PD Modification Application: PRS 26-0012

**Hillsborough
County Florida**

Development Services Department

The applicant is requesting to modify the PD as most recently modified under PRS 24-0634 to combine Blocks 5 and 9 into a larger block to allow for out parcels and multi-family residential dwellings including conventional and carriage house units.

8.2 Proposed Site Plan (Full)

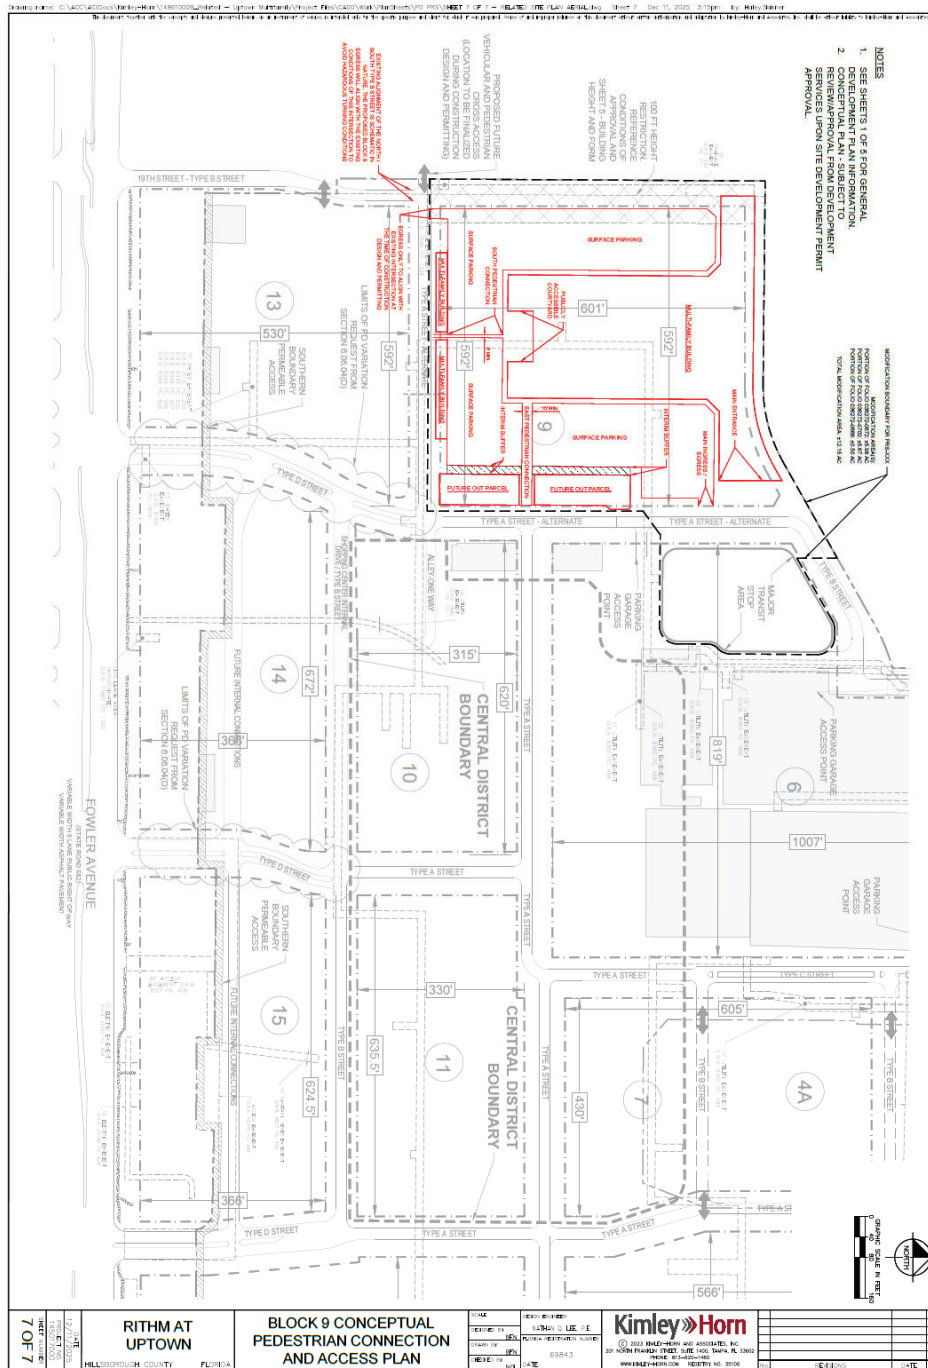
1. Remove note #2 on sheet 7 regarding the plan being “conceptual.”

Sheet 7 of 7 includes a conceptual layout for a multi-family development and future outparcels with a Type A Street -Alternative section along the eastern and southern perimeter consistent with the proposed changes to the Condition of Approval #5.20 a. addressing the type and timing of construction of said street.

- a. A wall or a hedge with a (minimum 42 inches high and a maximum of 72 inches high) shall be provided within the area labeled "Interim Buffering" on Sheet 7 of 7 if all of the following occur: (i) the multifamily uses are developed on Block 9 prior to the outparcels, (ii) 24 months have elapsed after the multifamily development receives the final Certificate of Occupancy, and (iii) the Applicant has not submitted building permit applications for the outparcels.

- b. The Applicant will provide a minimum of two of the following open space enhancements to the Main Entrance/Main Ingress/Egress area labeled on Sheet 7 of 7: accent hardscapes, public art, outdoor seating, pedestrian down lighting, water feature, or enhanced landscape element.

- c. The Applicant will provide a minimum of two of the following open space enhancements to the areas labeled "South Pedestrian Connection" on Sheet 7 of 7: accent hardscapes, public art, outdoor seating, pedestrian down lighting, water feature, or enhanced landscape element.

- d. The Applicant will provide a minimum of two of the following open space enhancements to the areas labeled "East Pedestrian Connection" on Sheet 7 of 7: accent hardscapes, public art, outdoor seating, pedestrian down lighting, water feature, or enhanced landscape element.

- g. The East Pedestrian Connection, the South Pedestrian Connection and the Publicly Accessible Courtyard on Sheet 7 of 7 shall be publicly accessible.

- h. The development of Block 9 shall be substantially similar to the layout set forth on Sheet 7 of 7.
- i. Development of Block 9 shall comply with the requirements of Conditions 5.5, 5.6, 5.12, 5.13, and 5.14.

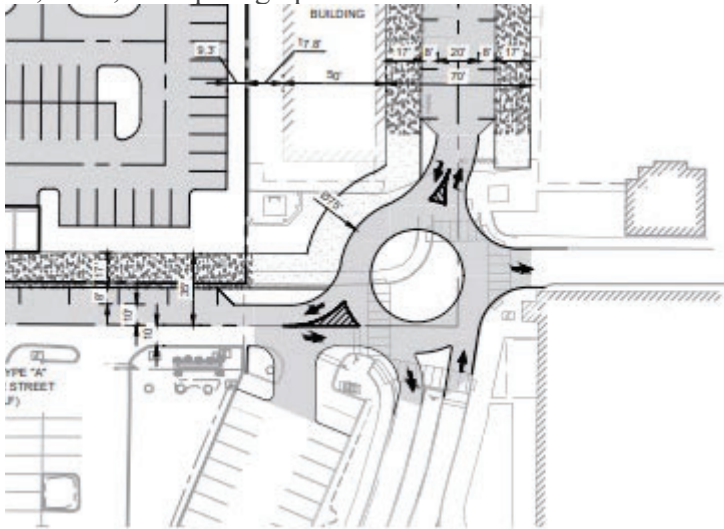
- Consolidate Blocks 5 and 9 into new Block 9,
- Eliminate the east west Type B Street between former Blocks 5 and 9,
- Eliminate the western Type B Street between Block 9 and the western PD boundary,
- Relocate the area designated for a major transit stop to a location east of new Block 9 on Block 6,
- Modify PD plan to set location for 19th Street future pedestrian and vehicular cross access,
- Update Land Use Table to reflect Replats and new parcel folio numbers assigned by Property Appraiser,
- Add new sheet 7 of 7 showing Conceptual Pedestrian and Access Plan for new Block, and
- Update all conditions accordingly.

While there is no change to the project's overall trip generation resulting from this modification, analysis of the internal circulation provided by the applicant's traffic engineer indicate that the consolidation of blocks 5 and 9 in conjunction with the elimination of the perimeter street abutting the north and west side of block 9 will result in a concentration of internal traffic at the adjacent north/south and east/west intersection at the southeast corner of the new Block 9. Supplemental analysis provided by the applicant's traffic engineer show this intersection operating at acceptable levels with a roundabout design as shown in the informational schematic submitted by the applicant on December 19, 2025, excerpted graphic below.
